Application no: R3.0138/21

Transport Development Control

Recommendation:

Roundabout on GA Plan 14

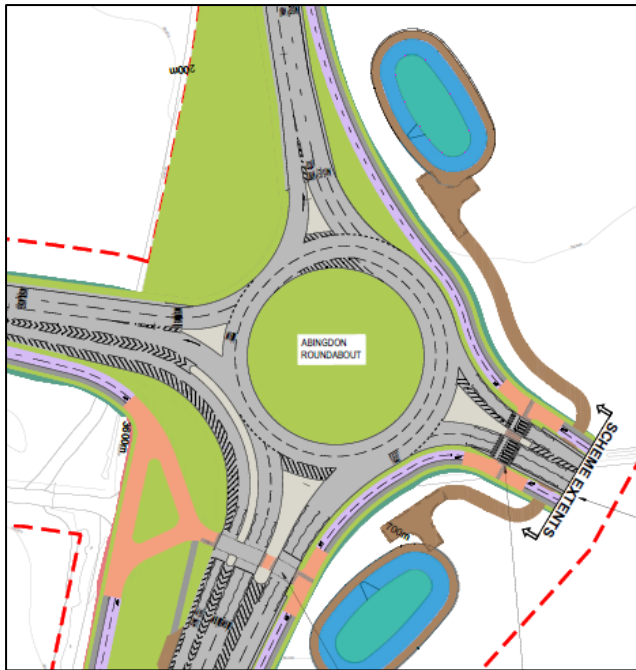
1.2.6. The areas marked in red, which were required to be amended and resubmitted, have been revised on GA plan 14, as shown below. This layout is now acceptable to OCC and no further comments are made.
